TECHNICAL INFORMATION

- Subject** ▶ Change of the Hex. Bolt for Fastening Center Cover
- For Models** ▶ LS711D, LS0811, LS800D
- Country** ▶ All countries
- Description** ▶ The bolt in the subject has been changed as illustrated below in order to keep Center Cover in its exact position.

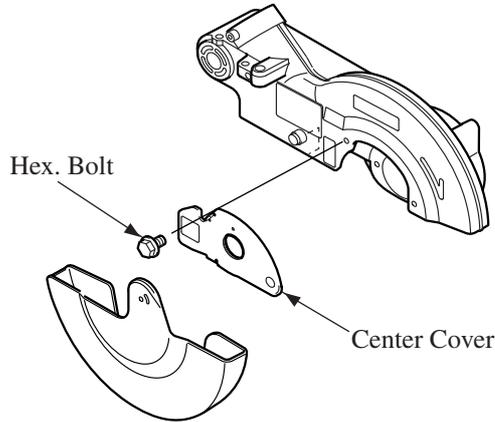
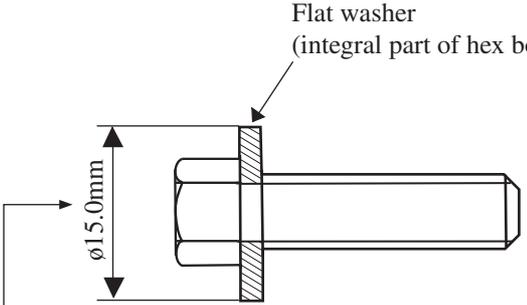
▶ Current	▶ New
 <p style="text-align: center;">Hex. Flange Head Bolt M6x12 (Part No.265260-3)</p>	 <p style="text-align: center;">Hex. Bolt M6x14 (265473-6)</p> <p style="text-align: center;">This new bolt presses Center Cover with larger surface.</p>

- LS711DW : From serial No.1076A (Aug.,1999)
Please note that the current bolt is used for serial No.1136A to 1315A.
- LS0811 : After the current part has been finished.
- LS800DW : After the current part has been finished.
